ADDENDUM NO. 1

RED CLAY CONSOLIDATED SCHOOL DISTRICT
WILLIAM F. COOKE, JR ELEMENTARY SCHOOL
2025 Graves Road, Hockessin, DE 19707

THE WHITING-TURNER CONTRACTING COMPANY
CONSTRUCTION MANAGER
131 Continental Drive – Suite 404
Newark, DE 19713
302-292-0676 (phone)
302-292-0683 (fax)

CSK015

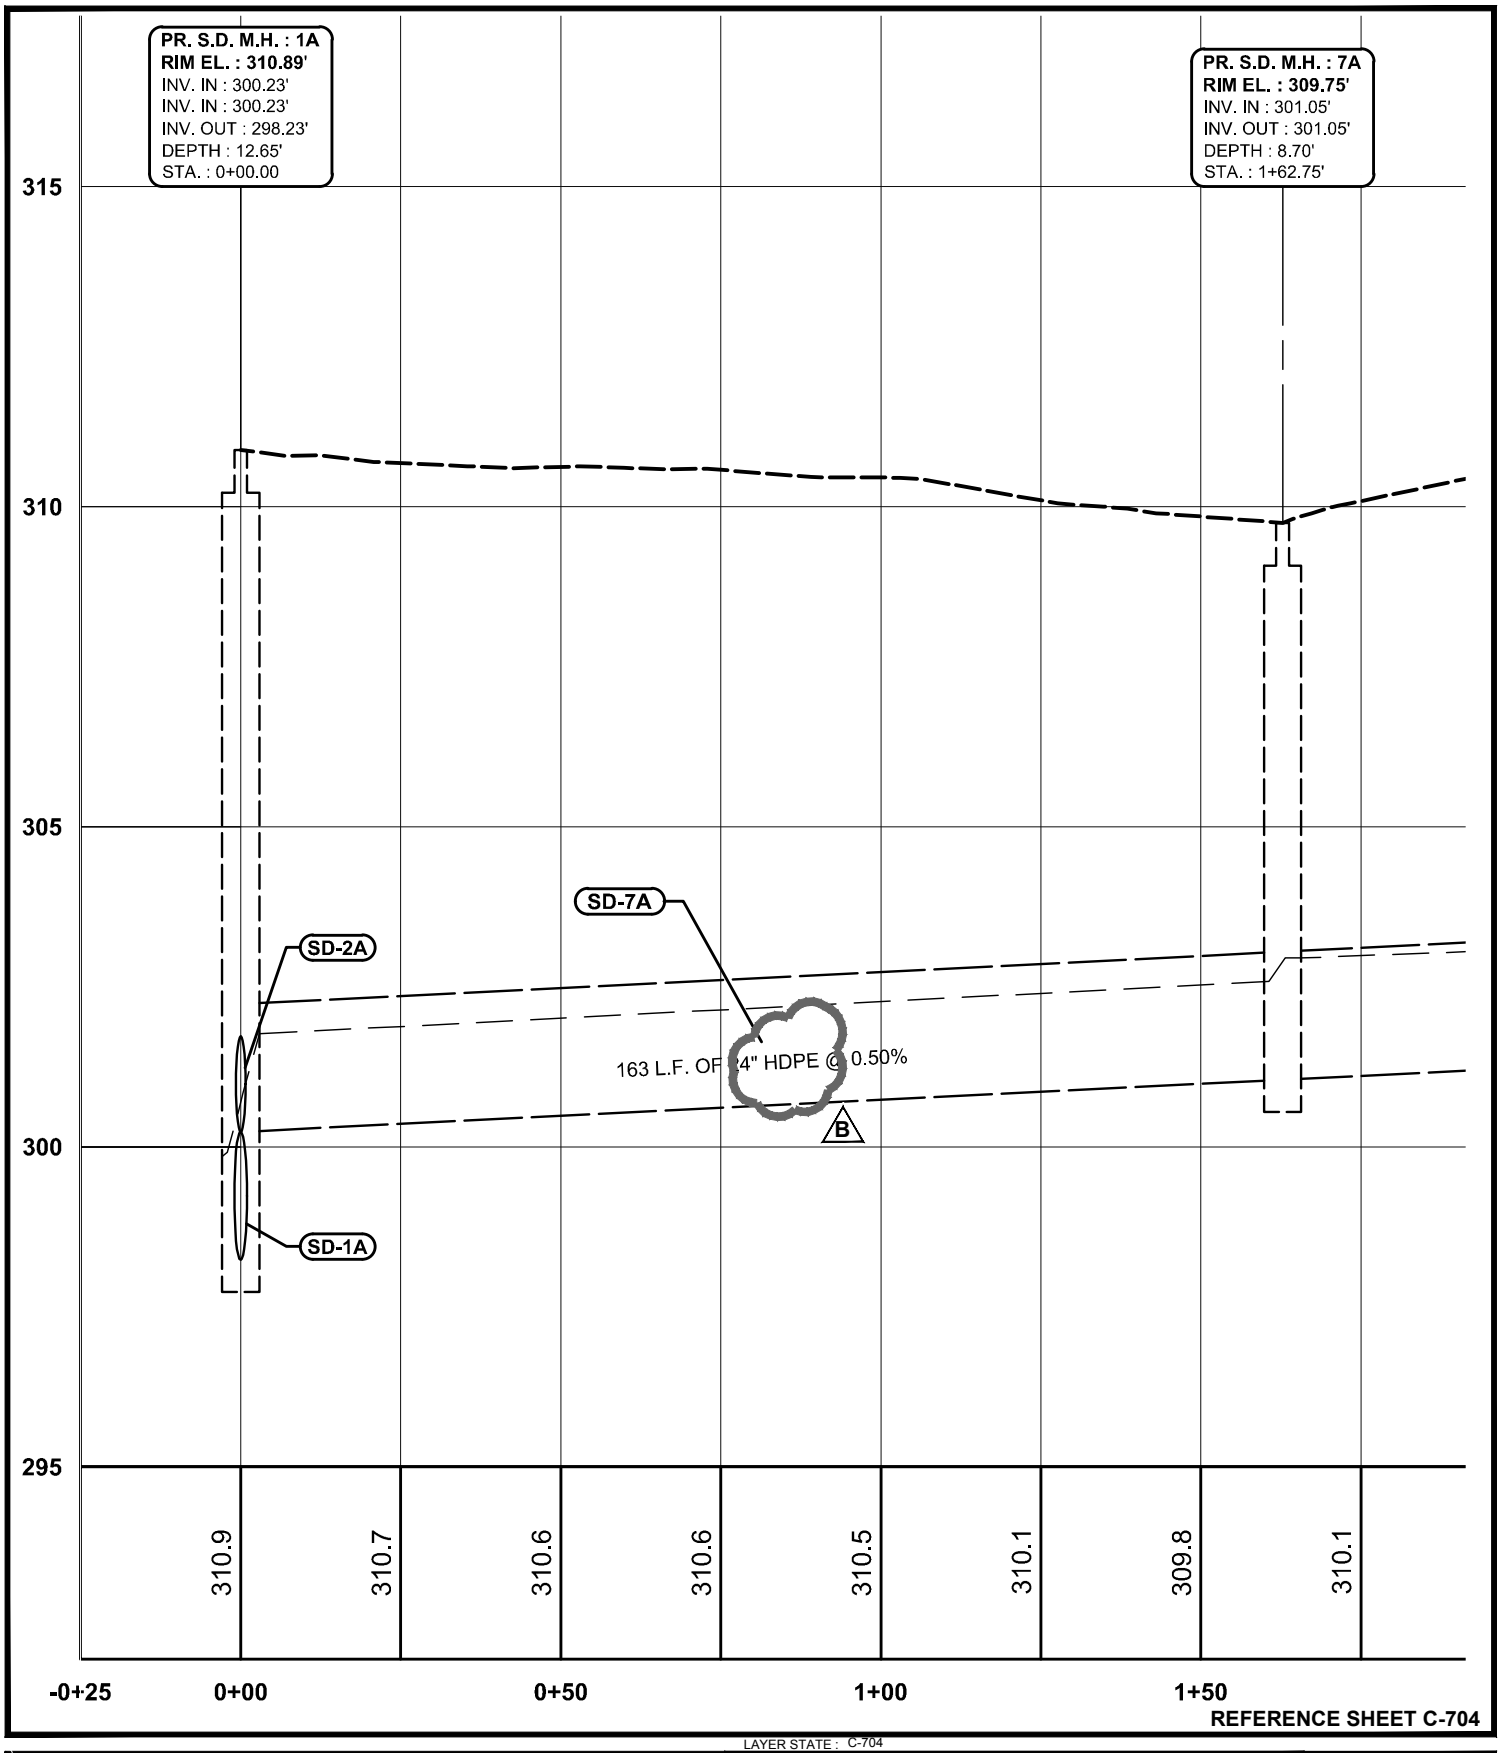
3.21 DRAWING C704 STORM WATER DRAIN PROFILE SD-1A to SD-6A
3.21.1 REVISE SD-7A, SD-8A, and SD-9A pipe material to "HDPE" to match storm drain pipe schedule per attached sketches CSK015 and CSK016.

1
SSK22

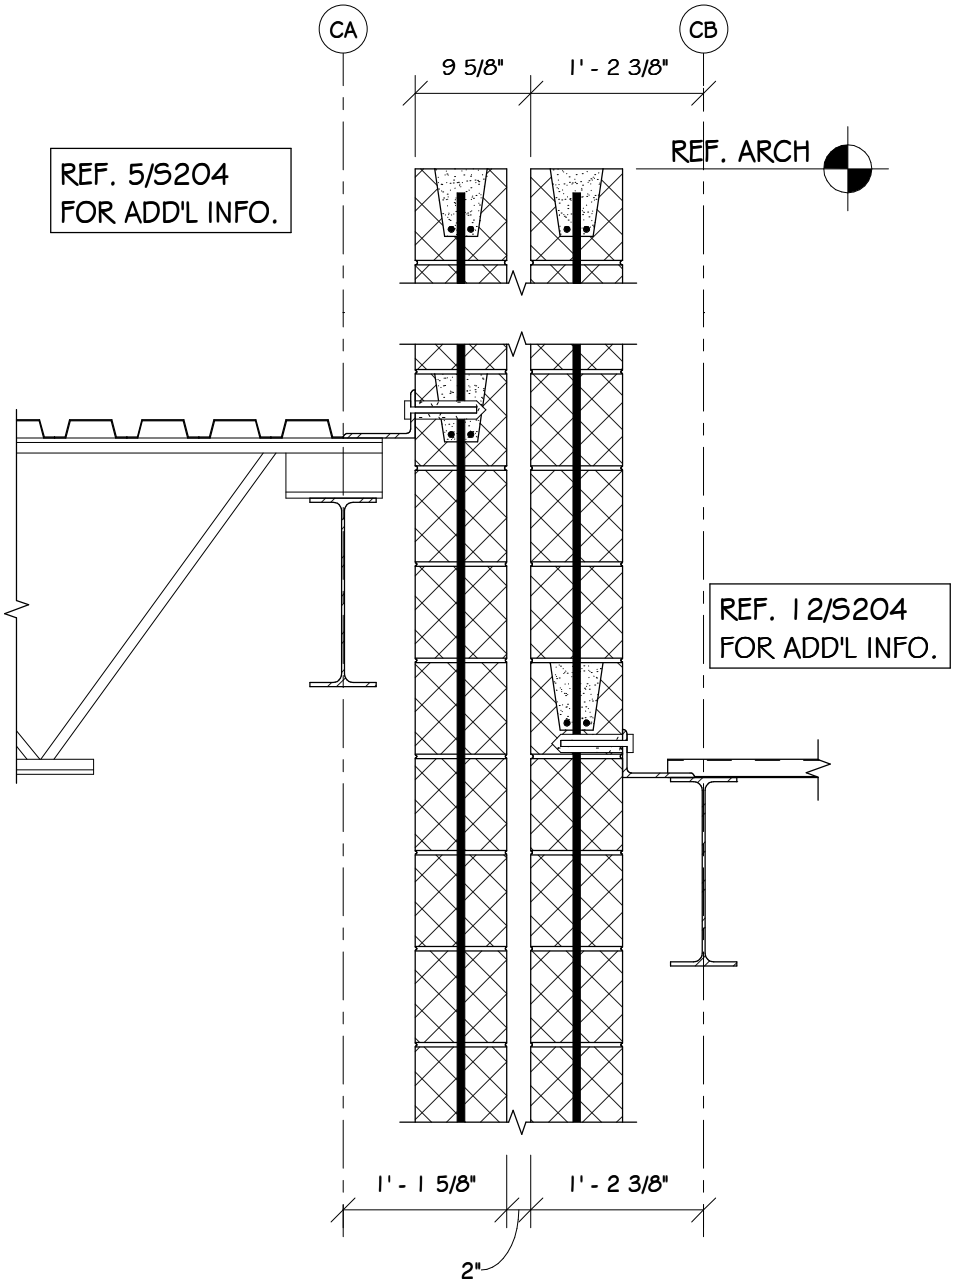
3.38.12 Detail 19/S202 - ADD attached sketch SSK22 along firewall between C6 & C1.

1
SSK24

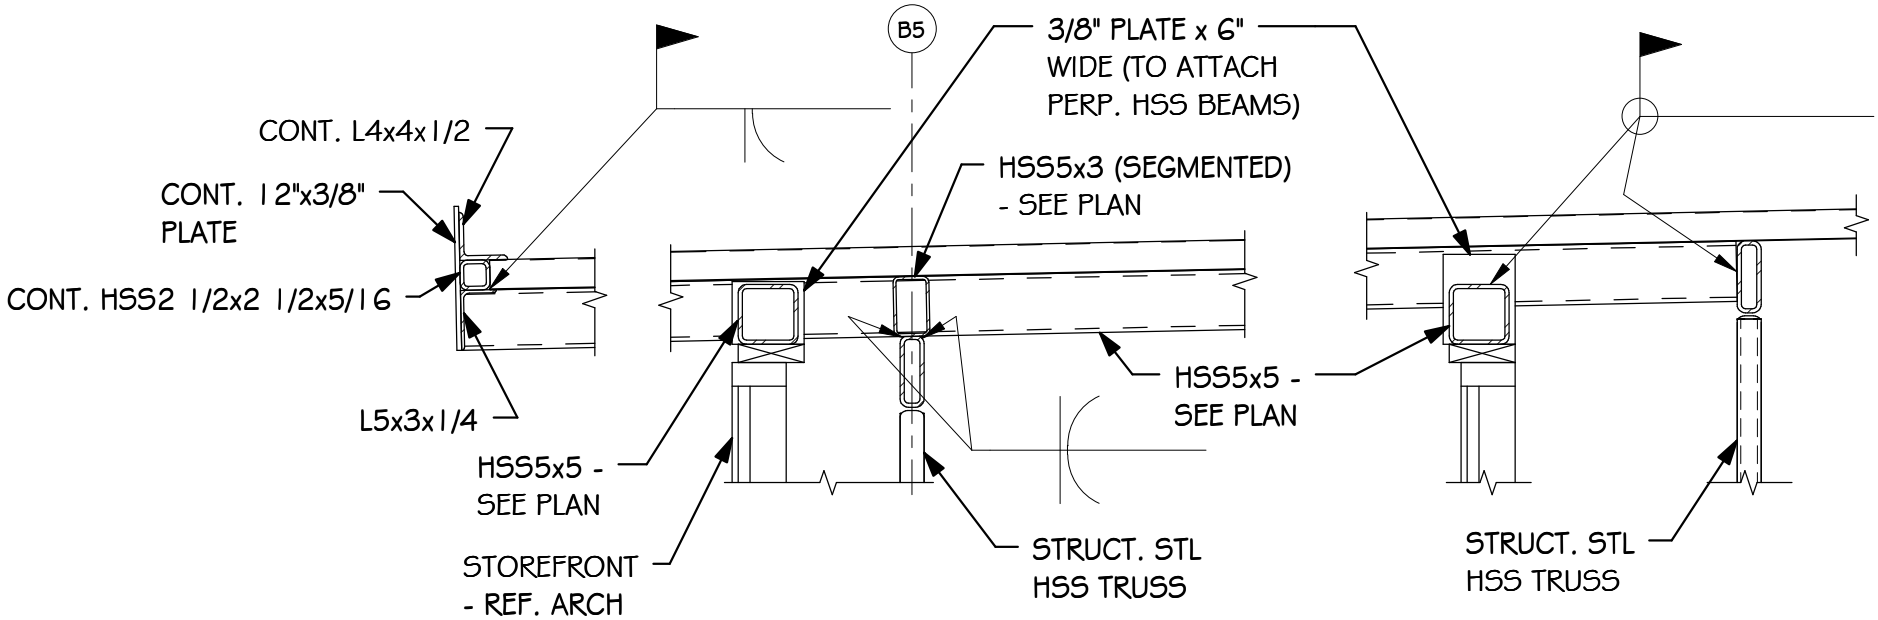
3.39.5 Detail 23/S203 – ADD attached sketch SSK24 at storefront and canopy along B5 between BS & BT.

1 FIRST FLOOR PLAN - AREA C
SCALE: 1/8" = 1'-0"

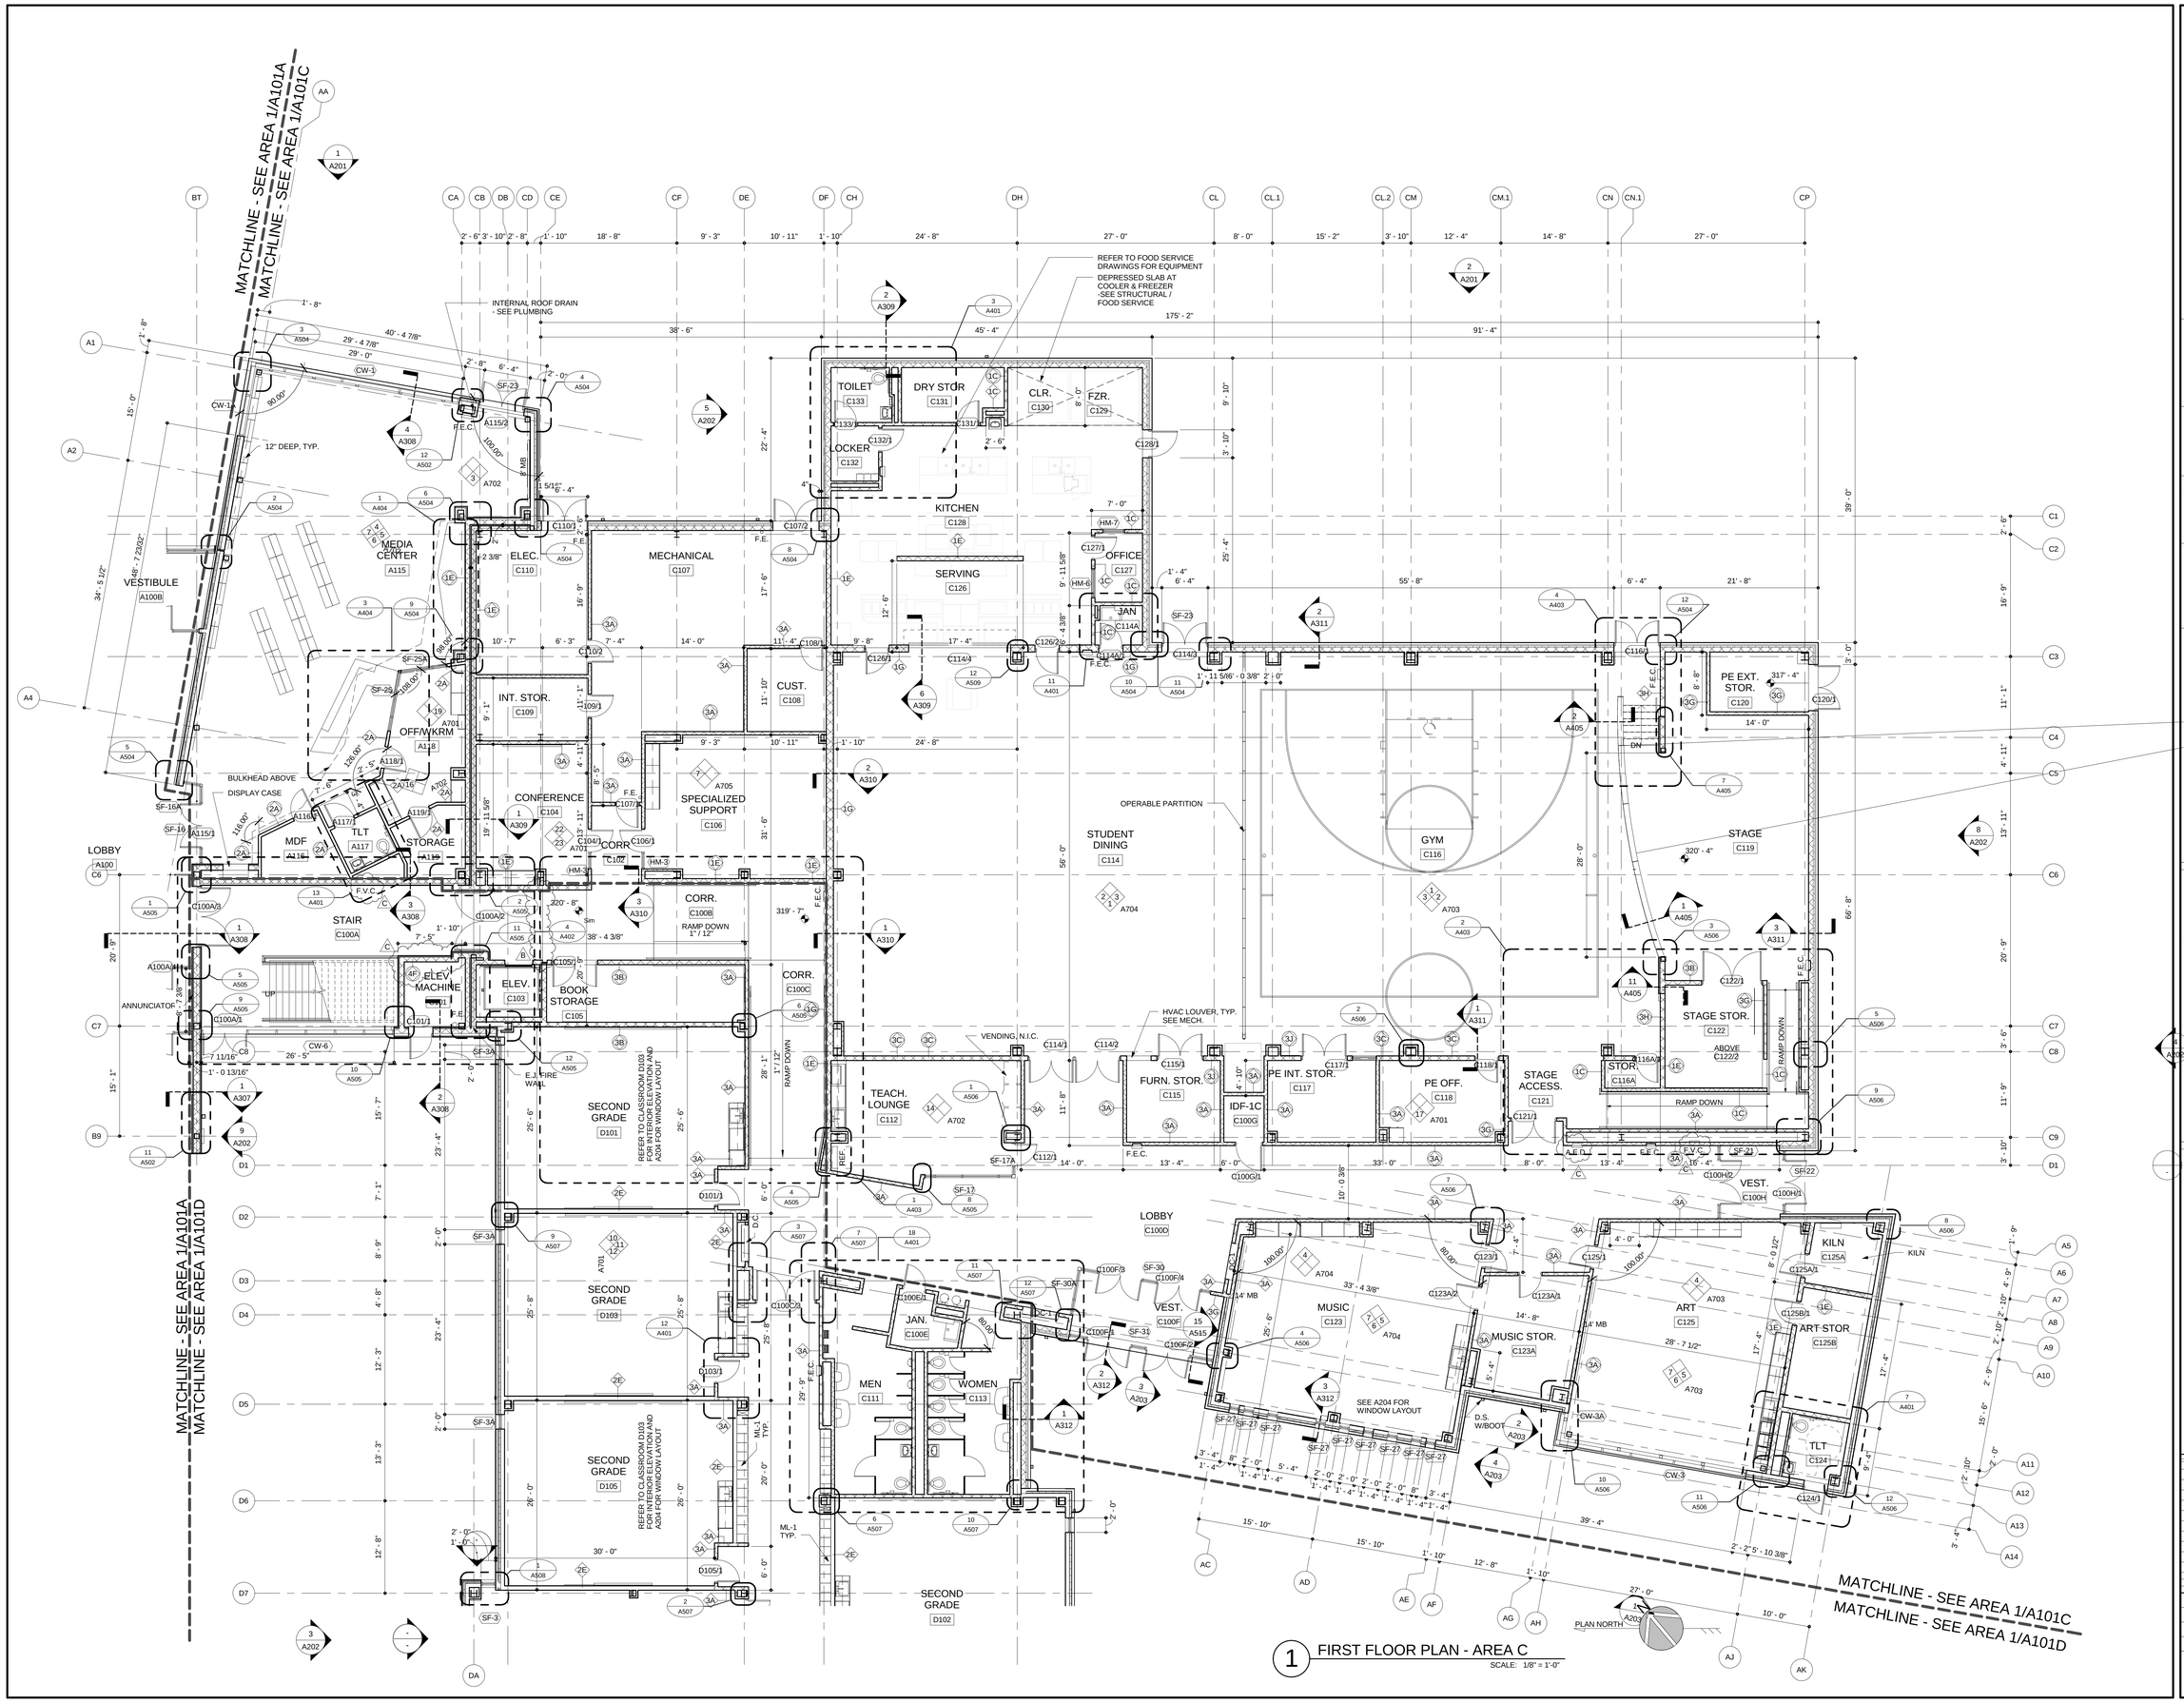
3.46.1 REPLACE Drawing A101C with drawing issued in this addendum.
3.46.2 DELETE wall at C100A
3.46.3 ADD Fire Protection cabinet at Lobby C100D
3.46.4 ADD Fire Protection cabinet at Stair C100A
3.46.5 ADD A.E.D. Cabinet at Lobby C100D
3.46.6 MOVE East wall of Elev. Machine Room C101, 8” to east.

1 ROOF PLAN

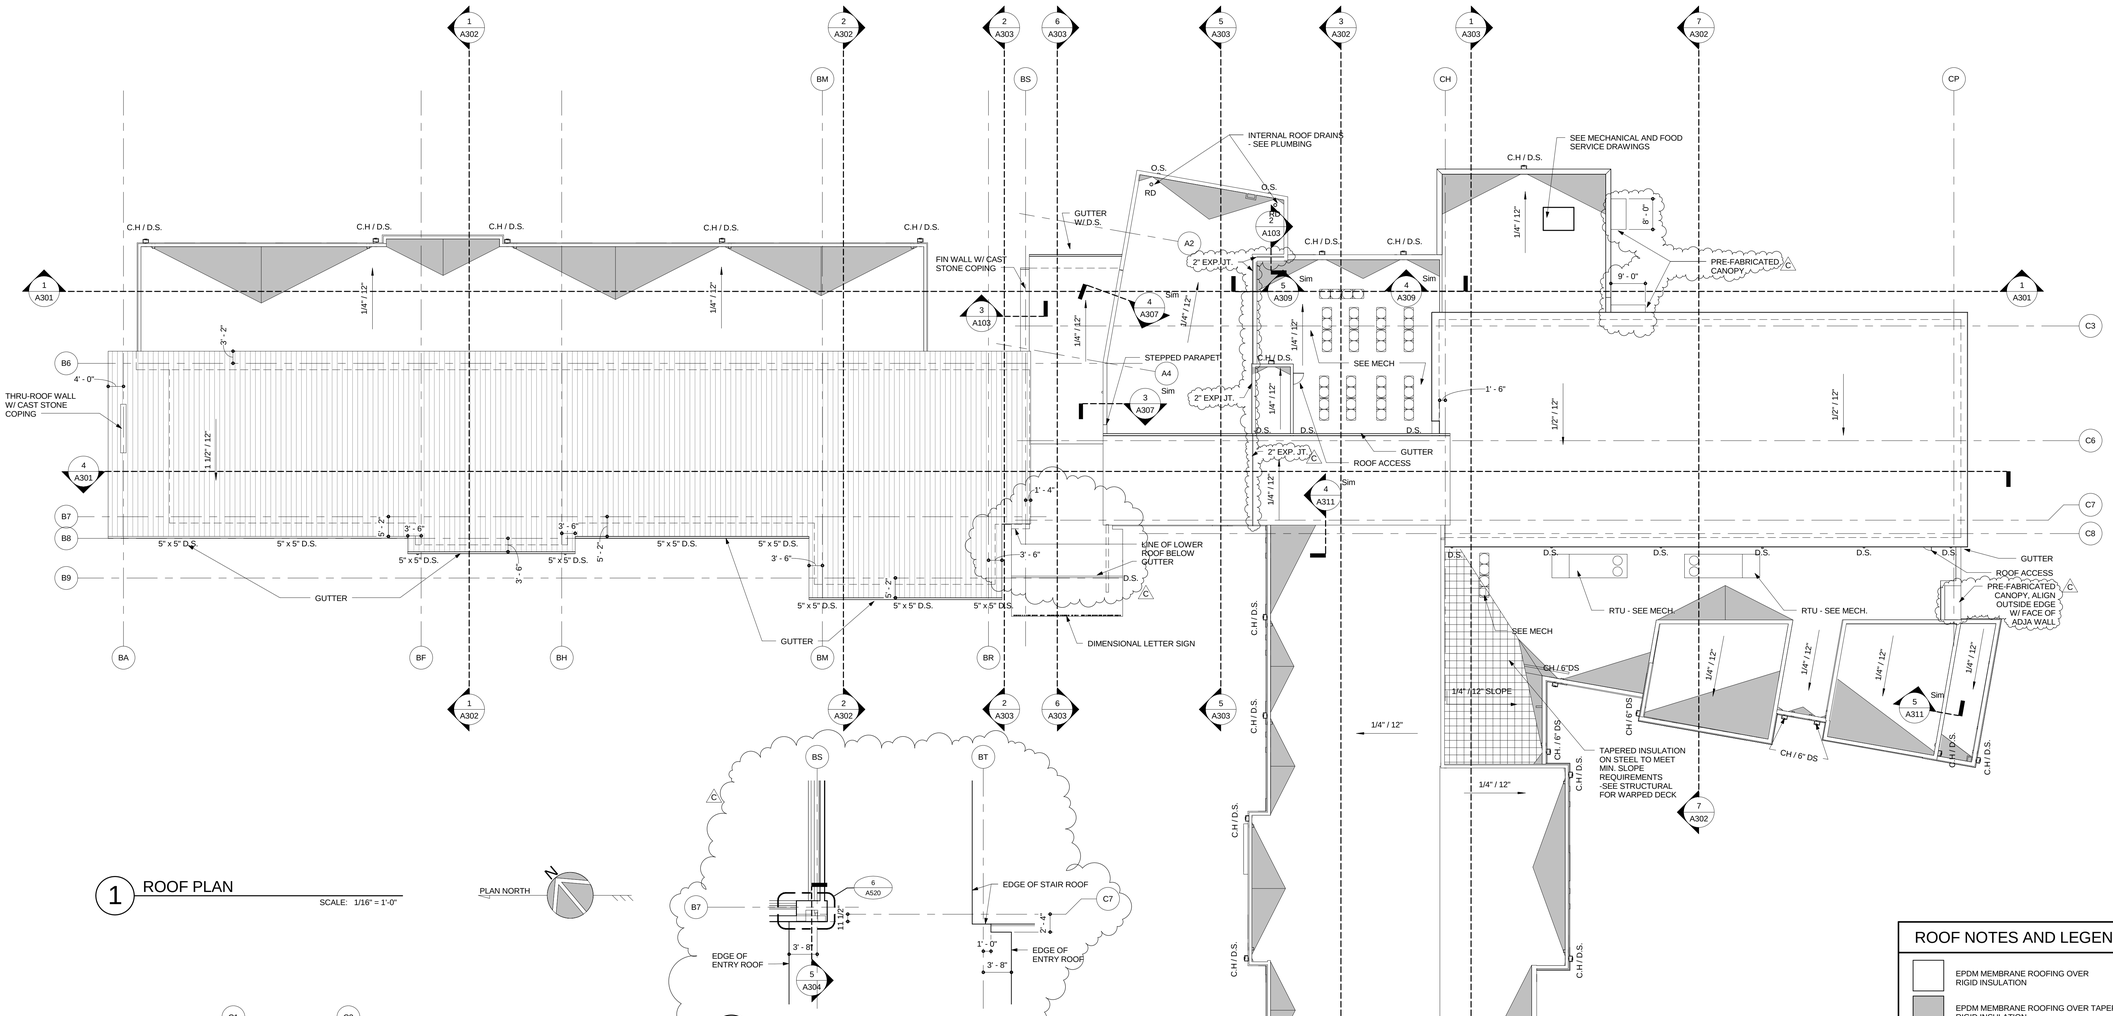
3.48.1 REPLACE Drawing A103 with drawing issued in this addendum.
3.48.2 ADD Partial Plan View 4/A103 for lower roof.
3.48.3 ADD Pre-Fabricated canopies at three (3) locations.
3.48.4 ADD 2” expansion joint at roof.
